Subject: Product Safety Recall 15021 - Inspection/replacement of IDM

Models: 2000-2002 Saab 9-3 and 9-5 (4 cylinder models)
2001 Saab 9-5 (6 cylinder models)

MODIFICATION INSTRUCTION

Check/replacement of ignition discharge module

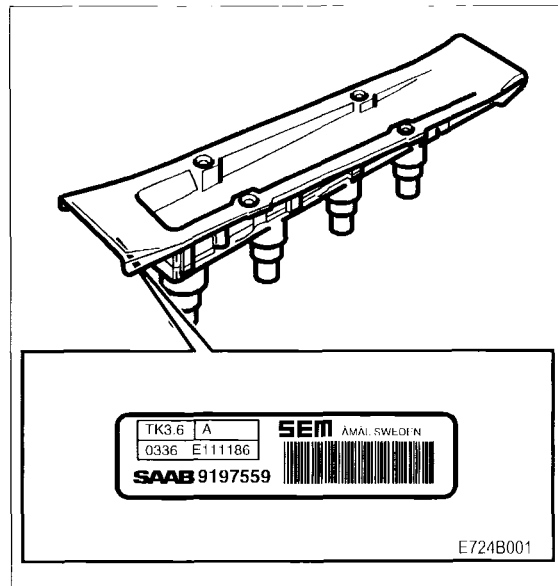
- 1 Remove the ignition discharge module as described in WIS - Engine - Trionic T7 - Adjust/replace - Ignition discharge module. Do not carry out "Extended ignition discharge module diagnose"
- 2 Check the serial number of the ignition discharge module. If the ignition discharge module is from the serial number interval below, it must be replaced. Other ignition discharge modules are not to be replaced.

B205/235: Serial number interval D000000 - D336210 or B083821 - B096117.

B308: Serial number interval C048743 - C072404.

- 3 Fit the ignition discharge module as described in WIS.

If the old ignition discharge module is to be refitted, lubricate it with Krytox.

New ignition discharge modules come pre-lubricated with Krytox and do not require additional lubrication.
